**MOTOR COACH
INDUSTRIES**

SUBJECT: SAFETY RECALL OF 2009 - 2011 MCI D SERIES COACHES

Service Bulletin No. 388

MODEL D Series Coaches	TYPE Field Change Program	SECTION/GROUP 7 – Electrical	DATE July 11, 2012
SUBJECT INTERIOR LED LIGHTS			
CONDITIONS

Figure 3. Connector S102 (splice clip connector design / brown color).

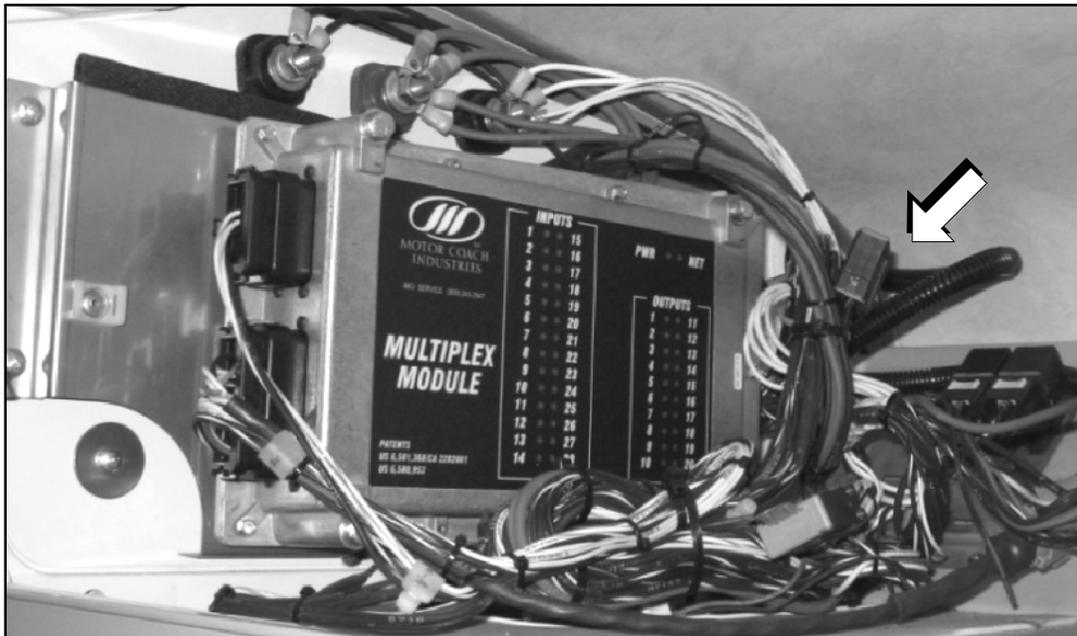
6. Locate connector S102 (refer to Figures 2 and 3).

7. Locate circuits A1, RA1 and LA1C in connector S102 cavities E, D and F. Using wire cutters, cut the wires 0.50 inch from the connector and splice them together using heat shrink, p/n 07-08-4684 (see Figure 4).

8. Locate circuits W1, RW1 and LW1C in connector S102 cavities L, K and M. Using wire cutters, cut the wires 0.50 inch from the connector and splice together using heat shrink, p/n 07-08-4684. (refer to Figure 4).

9. Using a small removal tool, remove circuit LW2A from connector S102 cavity J and splice with circuit LW2A from the Interior Light Relay Kit, p/n 07-08-4682 using heat shrink, p/n 07-08-4685 (refer to Figure 4).

10. Remove circuit RW2 from connector S102 cavity G and splice with circuit RW2 from the Interior Light Relay Kit, p/n 07-08-4682, using heat shrink p/n 07-08-4685 (refer to Figure 4).

11. Remove circuit LA3A from connector S102 cavity C and splice with circuit LA3A from the Interior Light Relay Kit, p/n 07-08-4682, using heat shrink p/n 07-08-4685 (refer to Figure 4).

12. Remove circuit RA3A from connector S102 cavity A and splice with circuit RA3A from the Interior Light Relay Kit, p/n 07-08-4682, using heat shrink p/n 07-08-4685 (refer to Figure 4).

13. Discard the connector S102.

Figure 6. Relay K location in curbside, parcel rack compartment #1.

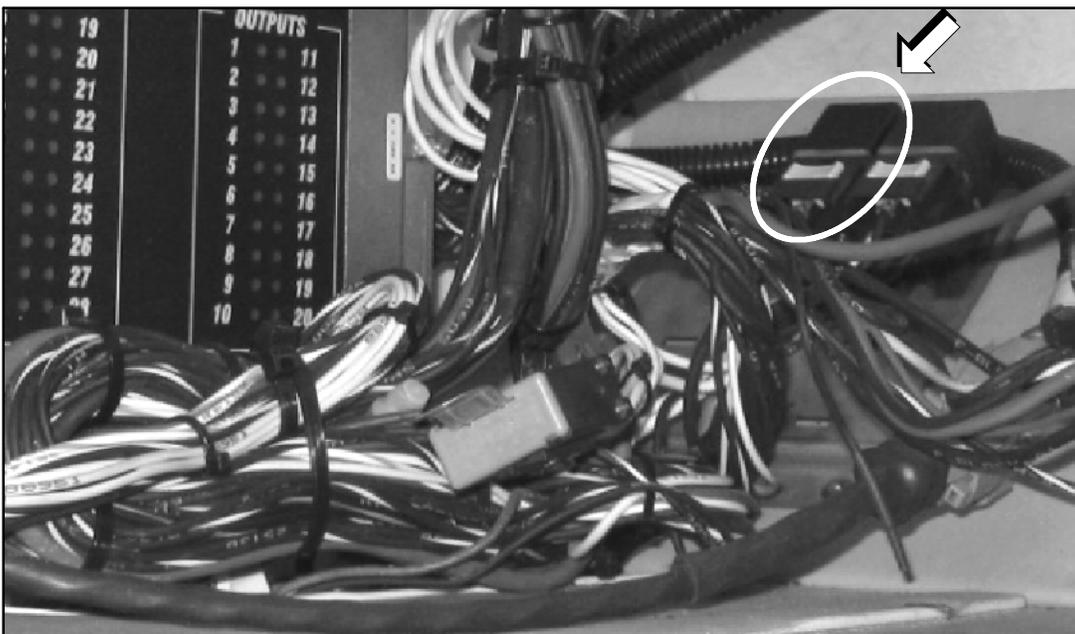
17. Locate Relay K (refer to Figure 6). Remove circuit 7029 from Relay K cavity 86 and splice with circuit 7029 from the Interior Light Relay Kit, p/n 07-08-4682, using heatshrink, p/n 07-08-4684.
18. Remove circuit 70291 from Relay K cavity 85 and splice with circuit 70291 from relay kit (07-08-4682) using 07-08-4684.
19. Discard Relay K and its base. Using wire cutters, cut and remove any other wire connected to the relay.

Figure 7. Fuse block in curbside, parcel rack compartment #1.

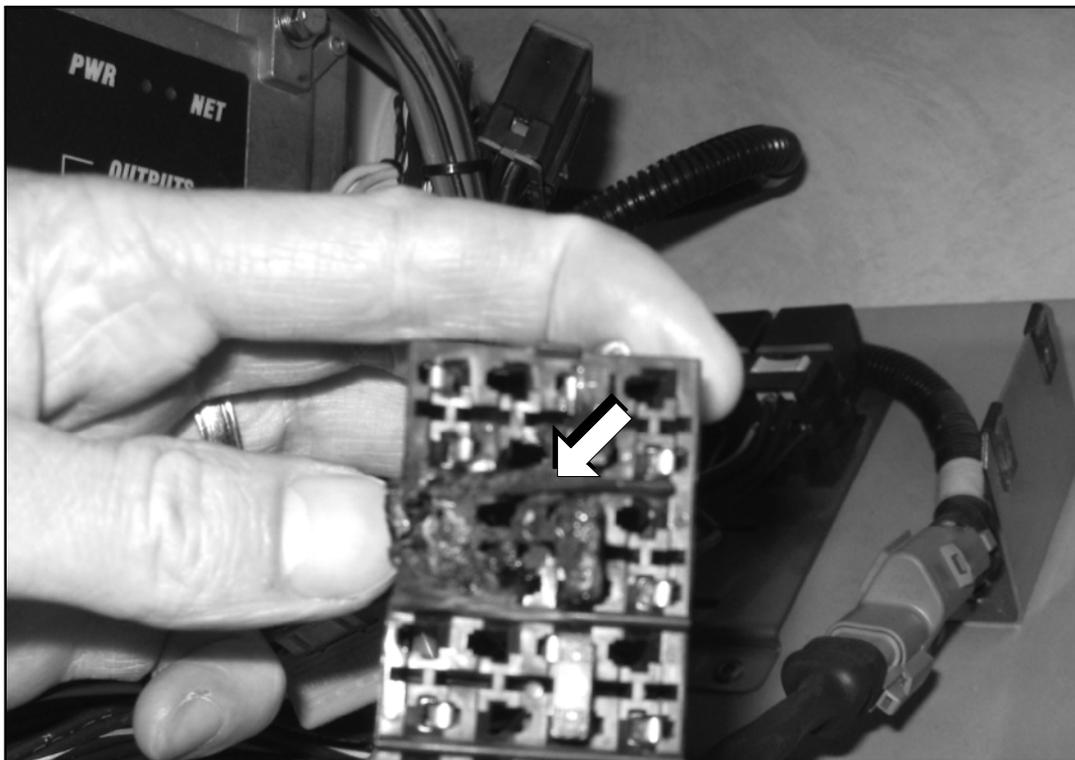
20. Visually inspect the fuse block for heat damage or melting at locations A1 and A2 (refer to Figure 7).

Upon visual inspection, if the fuse block exhibits signs of heat damage or melting, contact the MCI Fleet Support Technical Center at 1-800-241-2947 for further information and replacement parts.

Figure 8. Decal legend location on junction box cover in curbside, parcel rack compartment #1.

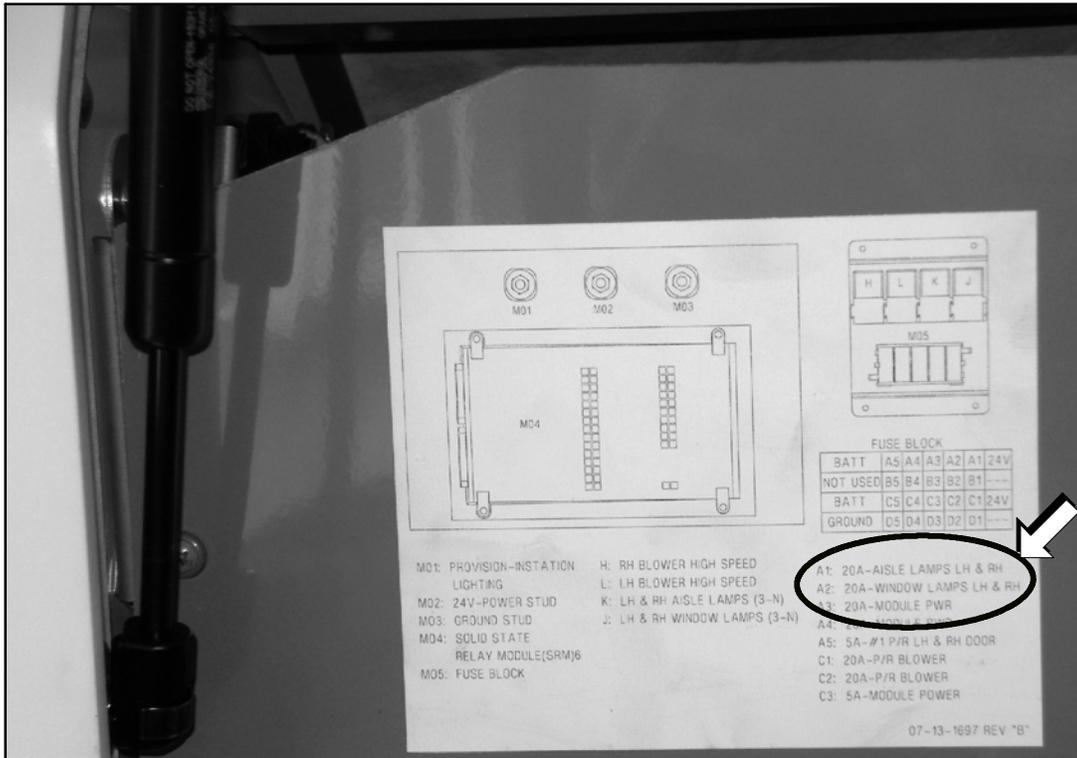
- 25. Using the mounting hardware removed in Step 5. , reinstall the junction box cover.
- 26. Using the decals, p/n 07-08-4682, cover locations A1 and A2 on the Decal legend affixed to the junction box cover.
